Addendum Number 3

Lake Peachtree Spillway Replacement Project

August 4, 2017

NOTE: SEGMENT G1 & G2 SIMILAR BUT OPPOSITE

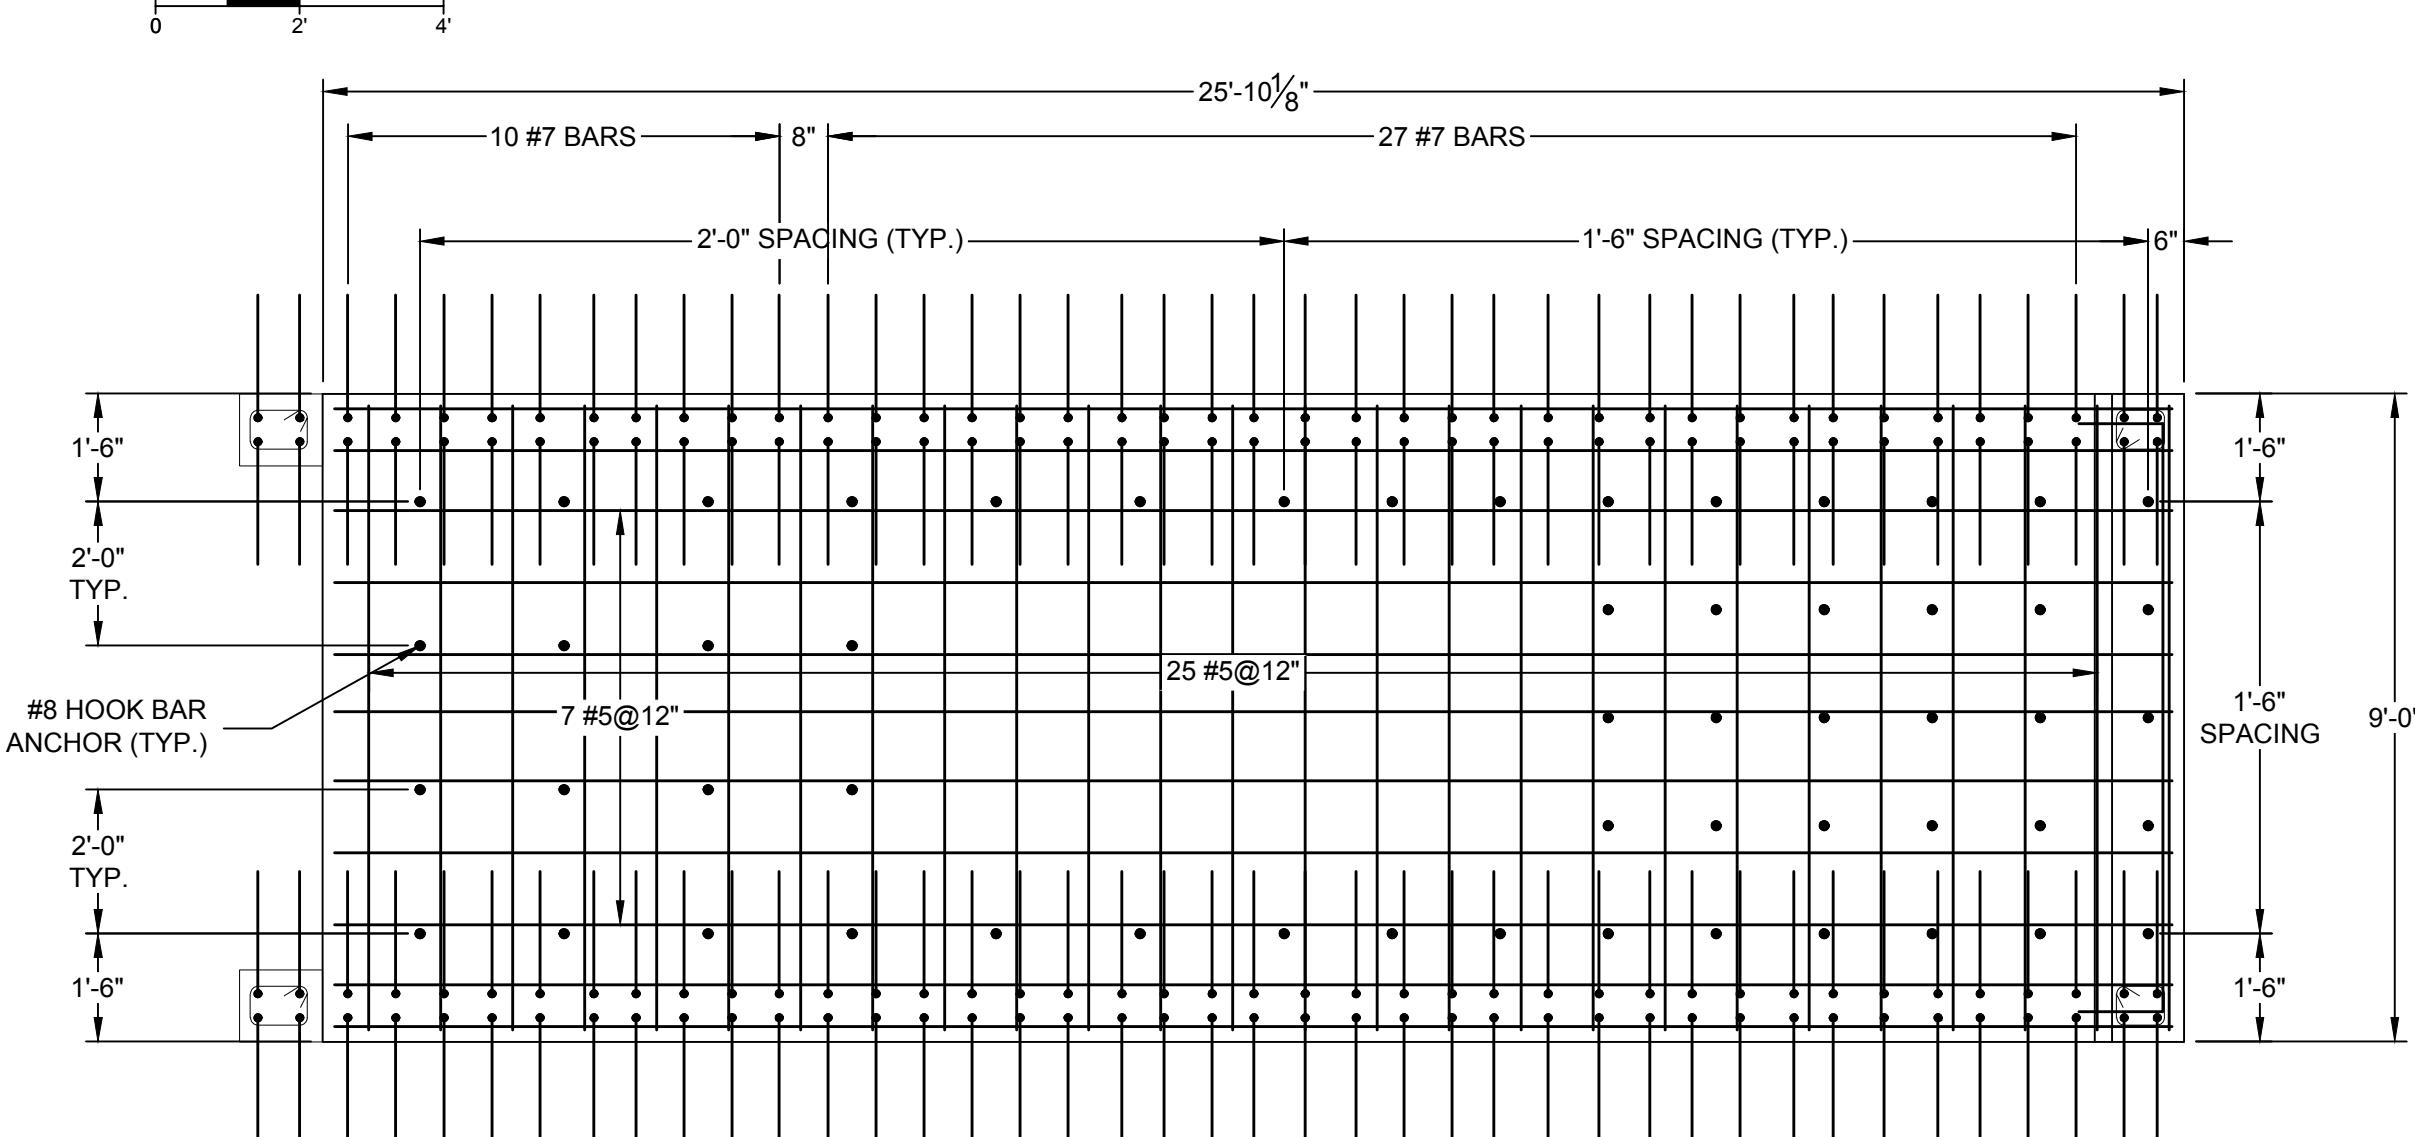
Note: Additional temperature and shrinkage reinforcing steel was added in the ramp/infill sections of the piano key weirs. Sheets with material changes were noted as Revised per Addendum No. 3. Sheets that were inadvertently affected by the changes are included, but do not contain revision clouds/call-outs. The additional reinforcing typically includes the addition of #5@12" spacing, #7@12" spacing, and #4@24" spacing depending on the specific locations of reinforcing.

PROJECT: 16C17043.00
DATE: 07/10/2017
SHEET
37 OF 66

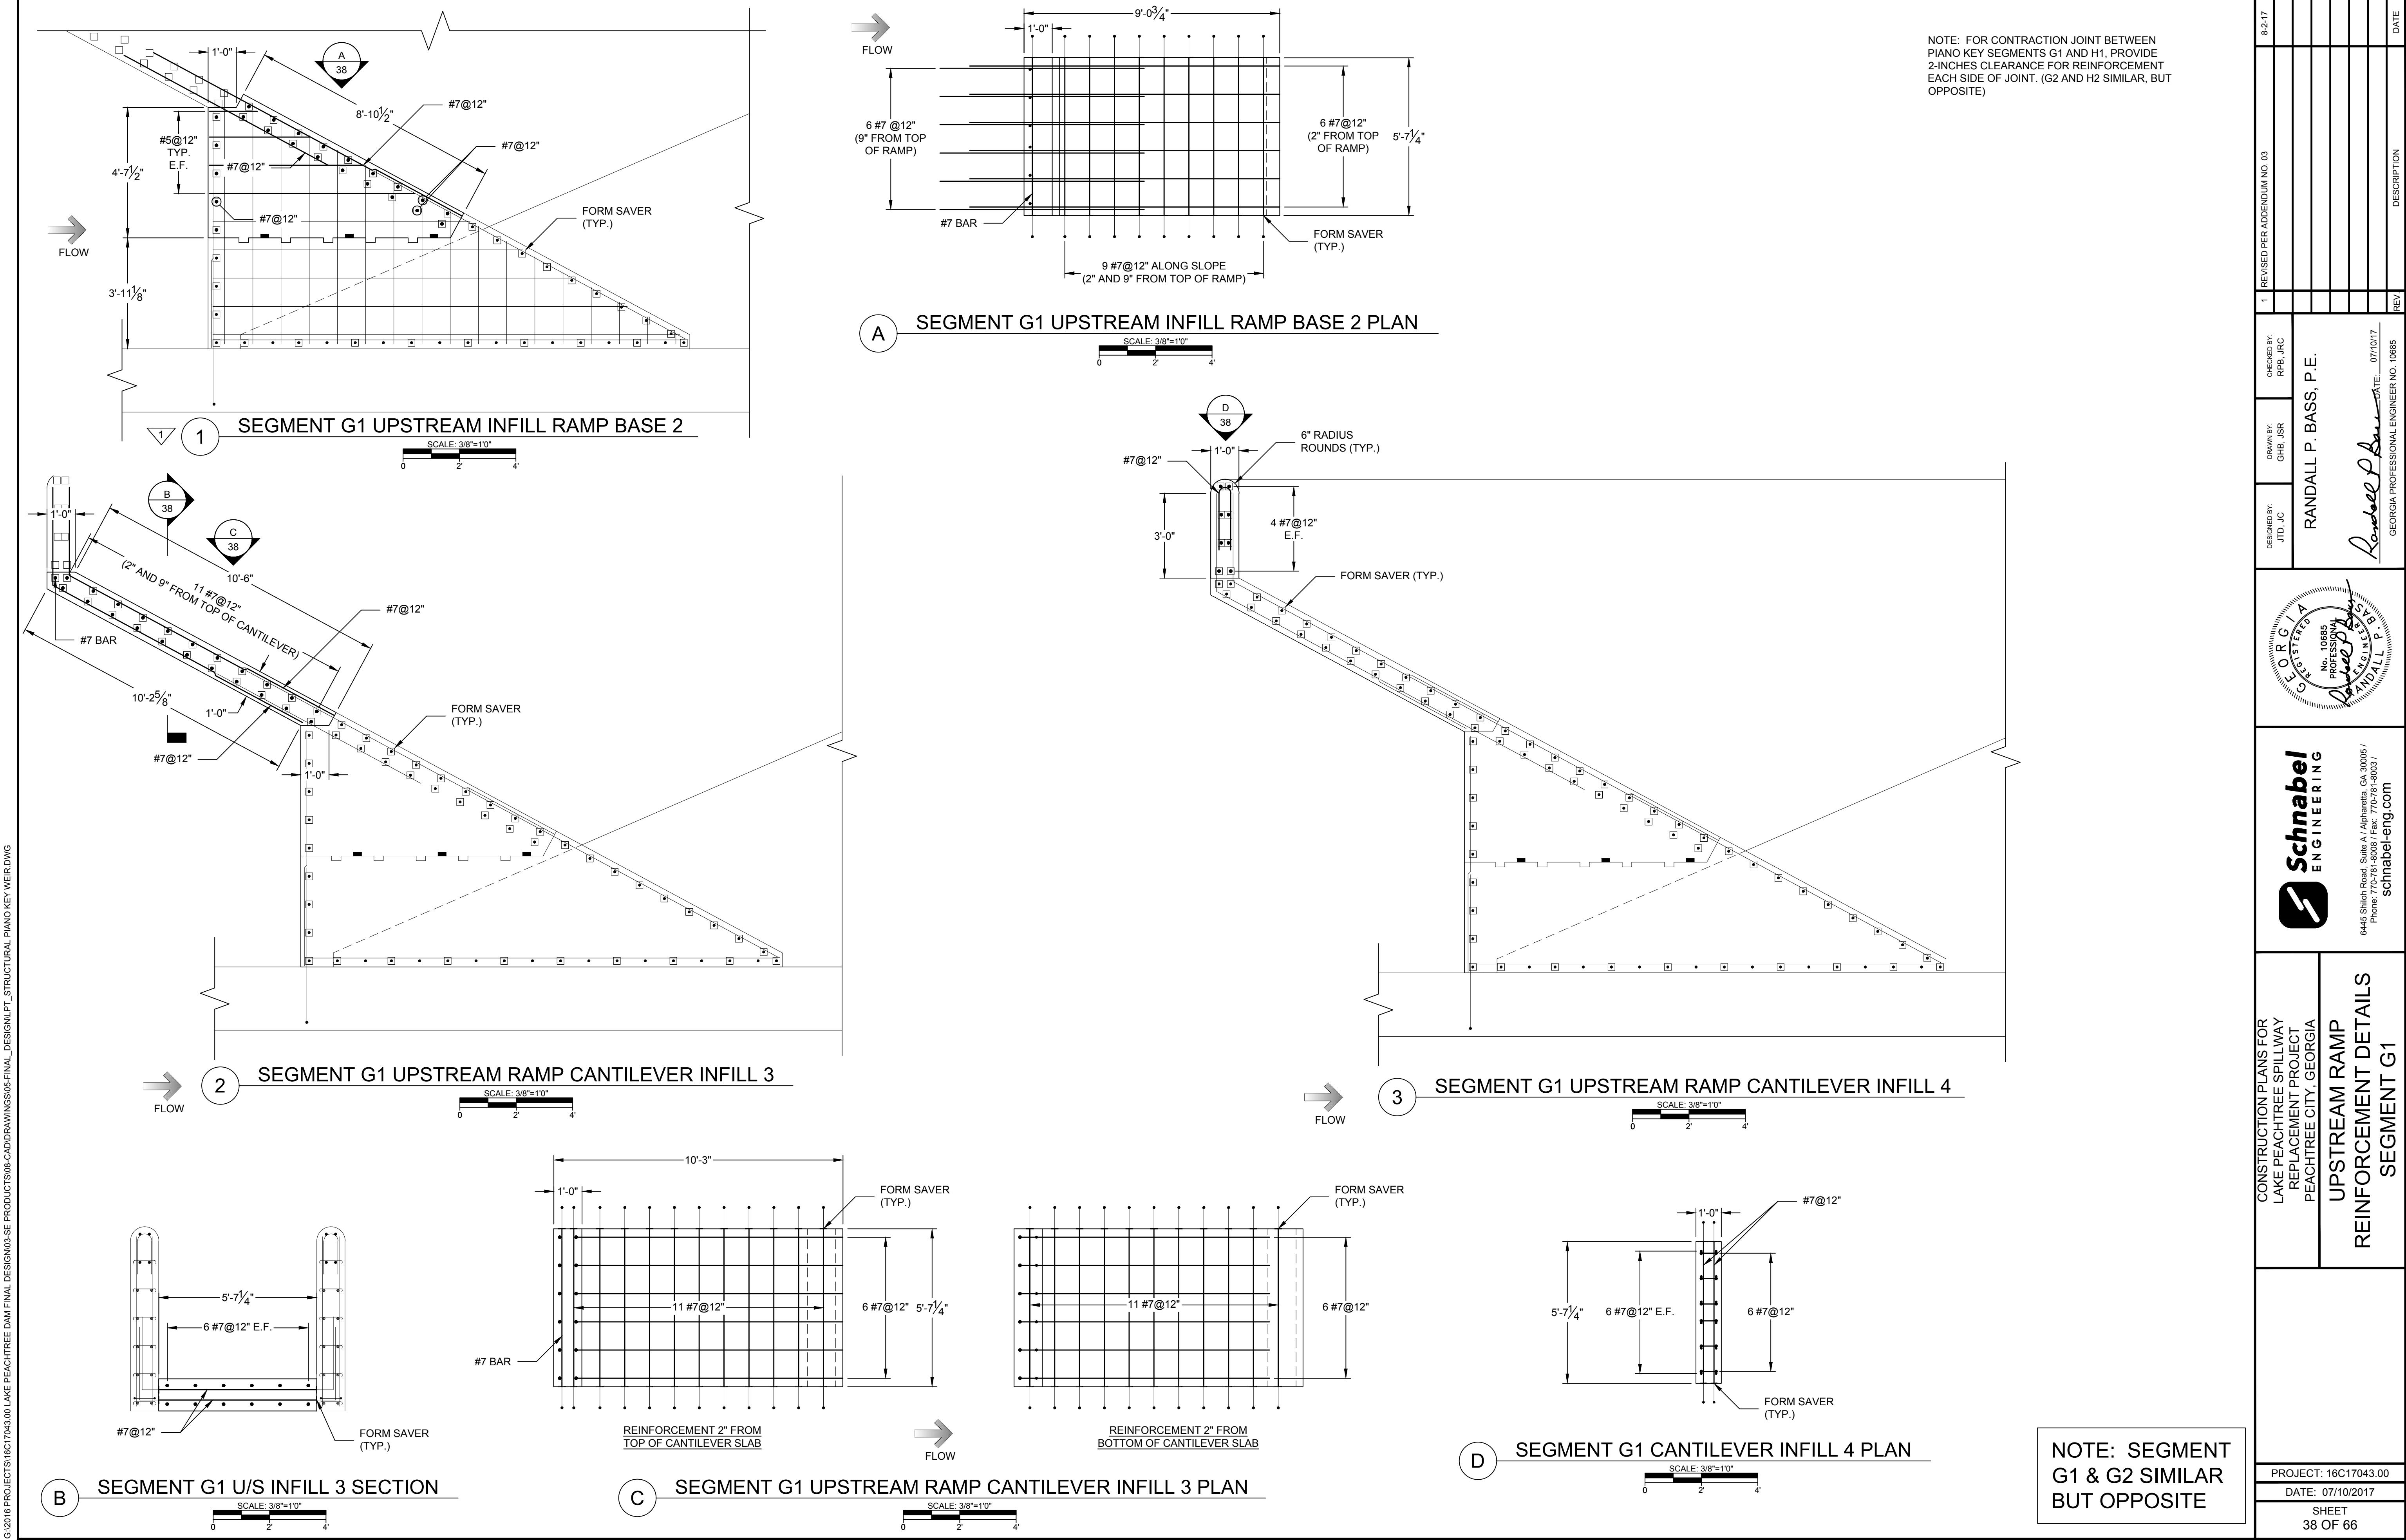
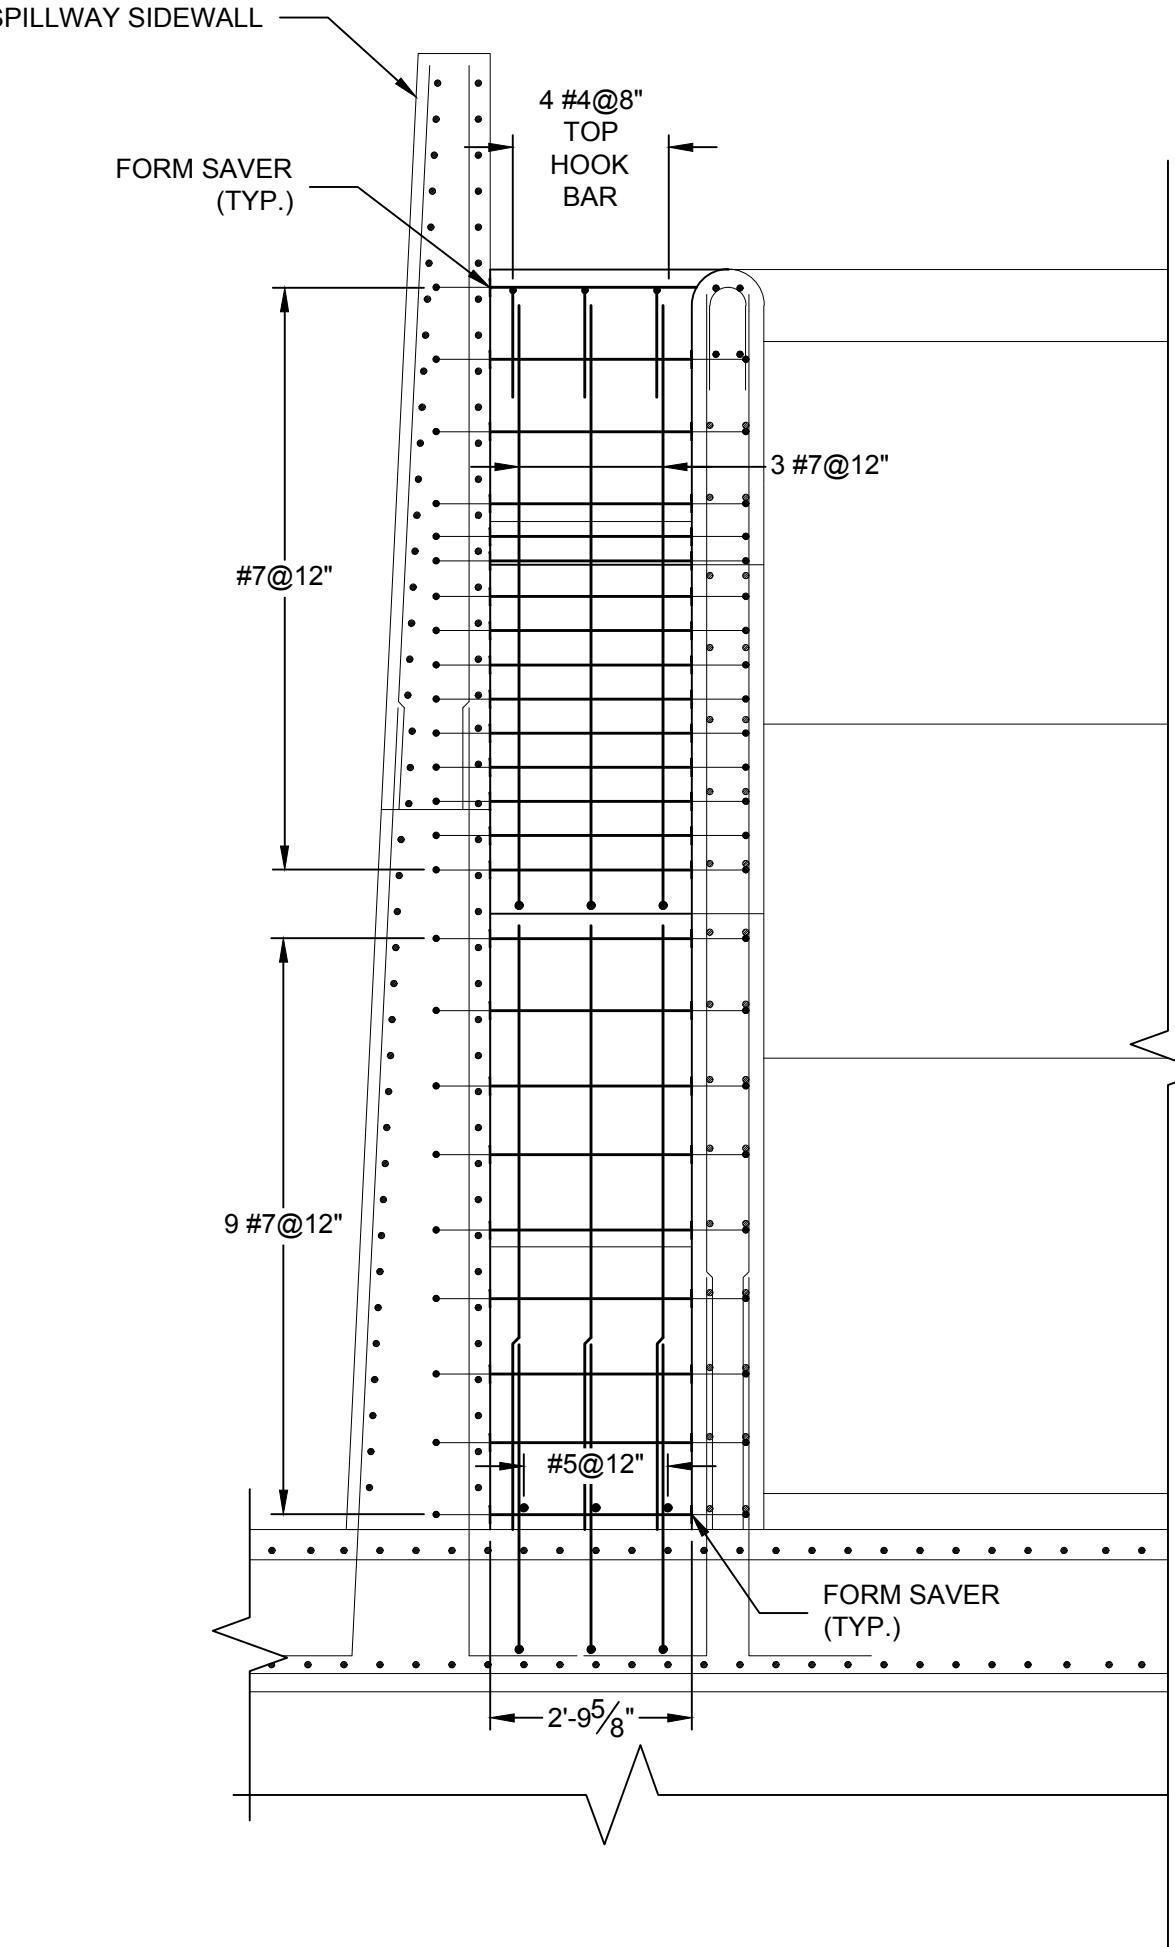
Note: The upstream ramp support walls (Sheets 37, 48, 53) were revised to include a 12-inch radius to improve hydraulic efficiency on the upstream ends of those walls.
